HISTORIC LANDMARKS COMMISSION

December 14, 2017

Subject: **REQUEST FOR CERTIFICATE OF APPROPRIATENESS HLC2017-021**,
submitted by Jeffrey Townsend, property owner, for exterior alterations (transom
windows) at property located at 178 East Washington Street. The property is
further identified as Zoning Map 34G18, Block (6), Parcel 5, Suffolk Voting
Borough, zoned CBD, Central Business District, and HC, Historic Conservation
Overlay District.

Subject: **REQUEST FOR CERTIFICATE OF APPROPRIATENESS HLC-2017-022**, submitted by Missi Cohn, agent for ForKids, property owner, for exterior alterations on property located at 119 W. Constance Road, Zoning Map 34G11 (1), Parcel R*2A. The affected area is further identified as being located in the Suffolk Voting Borough, zoned CBD, Central Business District and HC, Historic Conservation Overlay District.

HLC2017-021, 178 East Washington Street

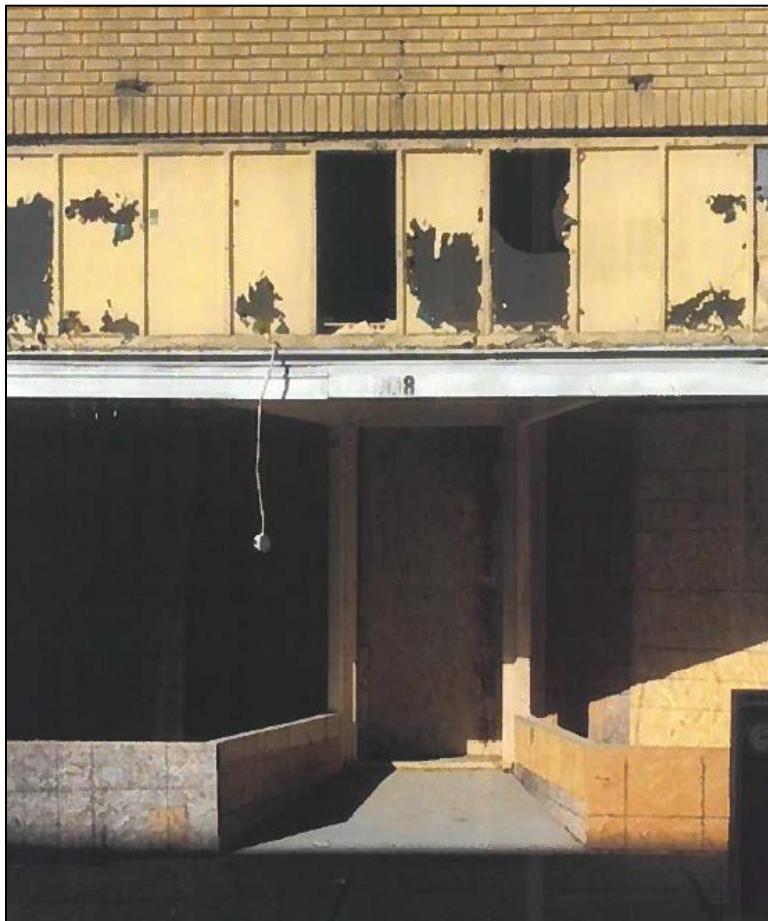
The applicant proposes to remove the preexisting nonconforming vinyl siding and original wooden transom windows and replace them with silver aluminum transom windows. In accordance with Chapter 4, Sections C and F of the Design Guidelines, Suffolk Glass and Aluminum submitted a condition statement in support of this application. Based on their field assessment, Suffolk Glass determined that the original wooden transom windows were rotten beyond repair and require complete replacement. The proposed design of the replacement windows is based on physical and pictorial evidence. The design consists of utilizing the original window opening, layout, pattern (200" x 40" in area divided into 10 equal sections), profile, and muntin configuration. Since the preexisting window frames had simple lines as opposed to intricate trim used on other structures in the district, the frames can be replicated using aluminum. While the replacement windows are proposed to be constructed of silver aluminum frames instead of wood, if the aluminum is painted with an appropriate color it will produce the same finish and overall appearance as the original wooden transom windows. Overall, the proposed replacement windows, if painted, will bring the building back to its historical appearance as they will profile the same as the original windows and frames despite the change in material.

Subject property prior to removal of vinyl area covering transom windows:

1. After-the-fact removal of the preexisting nonconforming vinyl siding and original wooden transom windows.
2. Install replacement aluminum transom windows that match the original transom windows in size, layout, pattern, dimensions, muntin configuration, and profile. Paint the aluminum windows utilizing an appropriate beige color from one of the approved paint palettes.
3. Fill in the area between the ground floor storefront windows and transom windows with painted wood trim utilizing an appropriate beige color from one of the approved paint palettes.
4. Any additional improvements shall require a Certificate of Appropriateness.
5. All required permits shall be obtained from the City of Suffolk.

Proposed design of replacement transom windows provided by Suffolk Glass, Inc.:

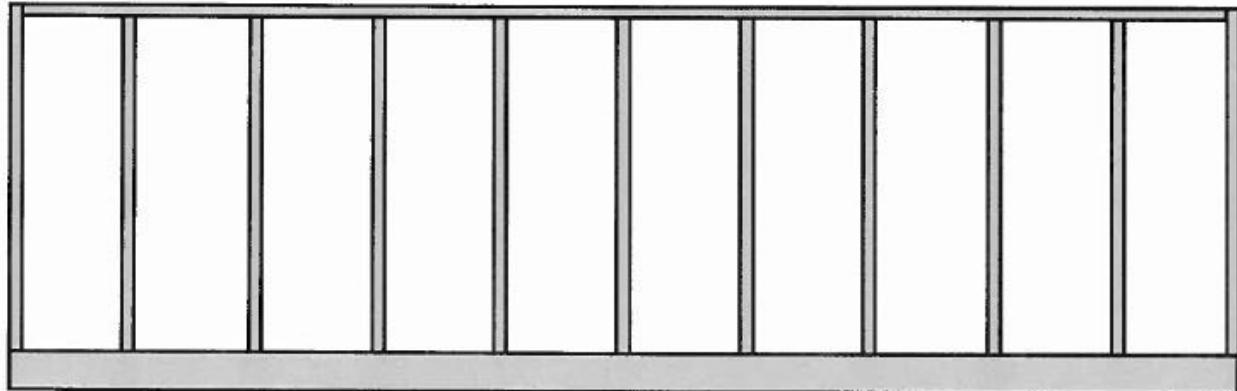
Note: This window will match size and make up of window section that was removed. New window section will be made with aluminum storefront and pattern 62 obscure glass. This will match the look of the downstairs section.

58 Banquet Hall
178 E. Washington St.
Suffolk, VA 23434

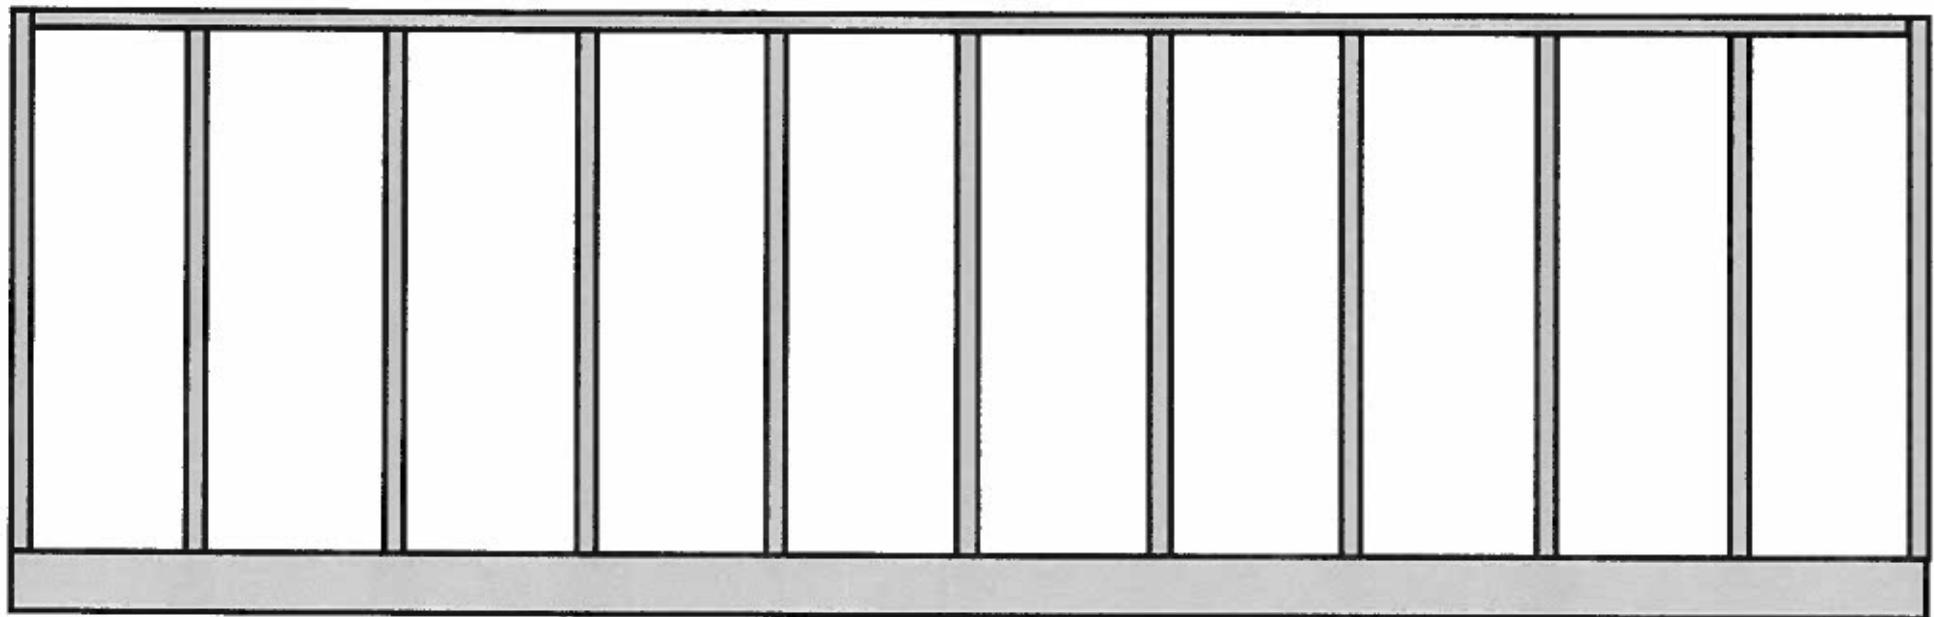
Upon my field assessment on the upper window section. The window section had badly rotted portions which left nothing to reattach this to the building. This was removed as a public safety measure since the framing was damaged over time from the roof leakage. It will be rebuilt with aluminum framing to match the downstairs entry system. Layout of the window will be the same as before 200" x 40" divided into 10 sections as seen on drawing provided. New wood will be cover will break metal and caulked to match the rest of the frame work and will provide decades of use.

Note: This window will match size and make up of window section that was removed. New window section will be made with aluminum storefront and pattern 62 obscure glass. This will match the look of the downstairs section.

HLC2017-022 119 W. Constance Street, North Elevation

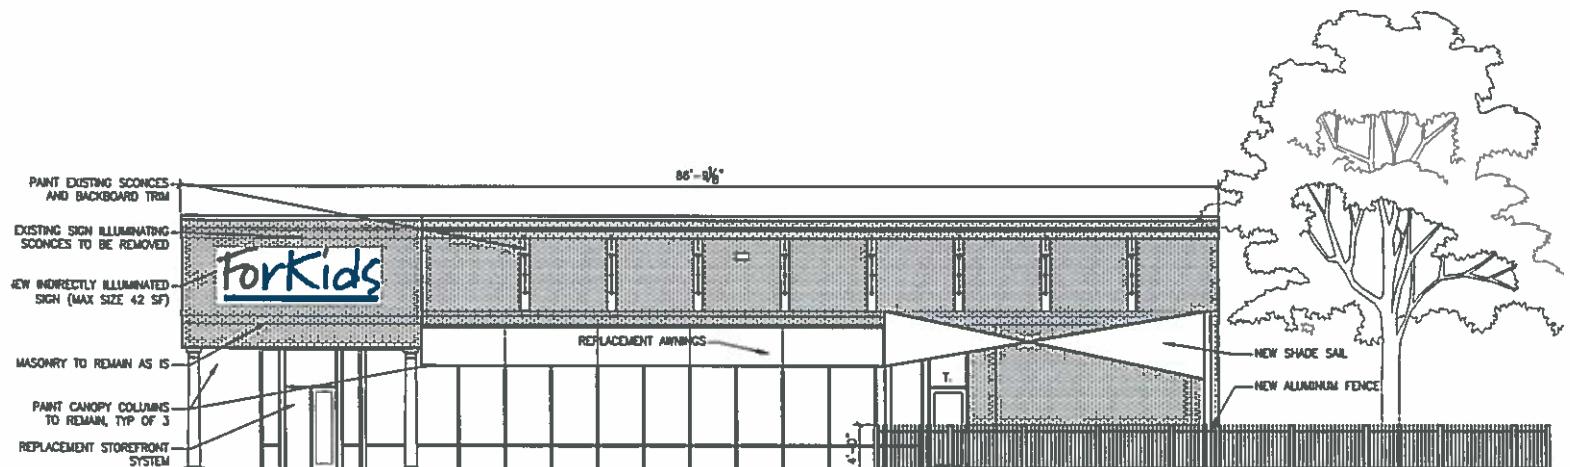
The two (2) new wall signs will replace two (2) existing wall signs located on the north and east elevations of the building on the entry canopy. The signs are proposed to be a maximum of 42 square feet in size and be indirectly lit, utilizing a light halo around the letters. The proposed signs are consistent with the requirements outlined in Chapter 6, Section E.2 of the Historic District Design Guidelines, which states "Lighting of signage must be indirect. Signs which are internally illuminated are prohibited." The existing gooseneck lights, that are used to illuminate the existing signage, will be removed. The sign lettering will be consistent with CW610 Stencil Square Wallpaper Blue and the detail under the copy will be consistent with CW510 Everard House Willow both from the Pratt & Lambert Williamsburg Color Collection Palette. As proposed, staff finds the proposed signs appropriate and consistent with the Historic District Design Guidelines.

HLC2017-022 119 W. Constance Street, South Elevation

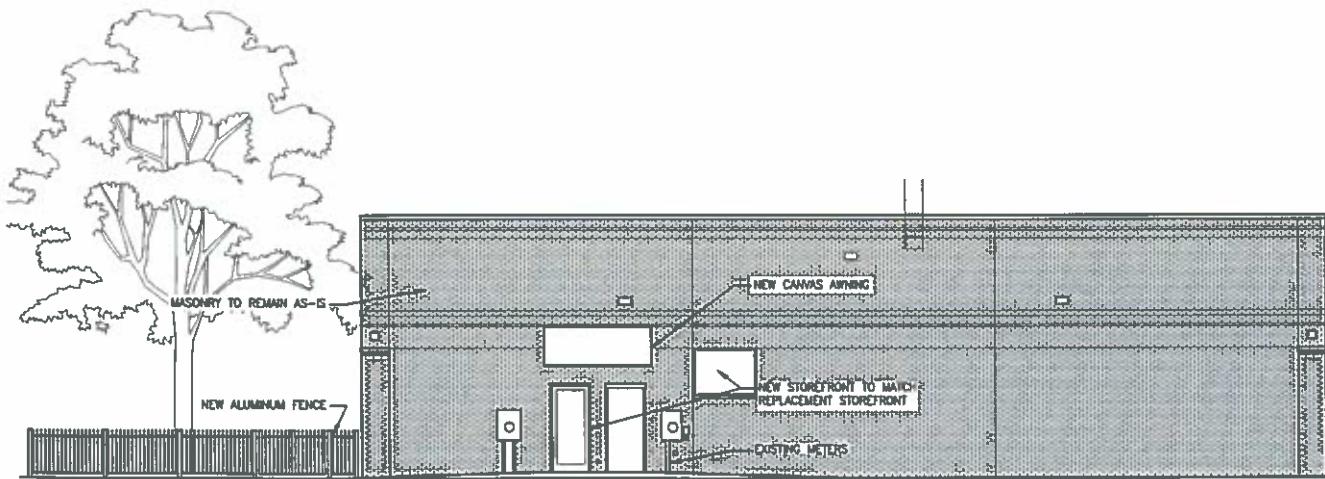
will be replaced with a glass door, and a fixed pane window will be installed. The installation of window and door openings on this elevation will offer some welcomed fenestration. On the west elevation (Church Street) a new aluminum window and door combination will be installed along with two additional fixed pane windows, all of which will work to help break up this currently blank façade. While the replacement storefront does not provide a significant change from the current storefront, the newly installed storefront in areas that currently lack openings are encouraged when consistent with materials and architectural details already in use, as is true in this case. As such, this improvement is supported by the Historic District Design Guidelines.
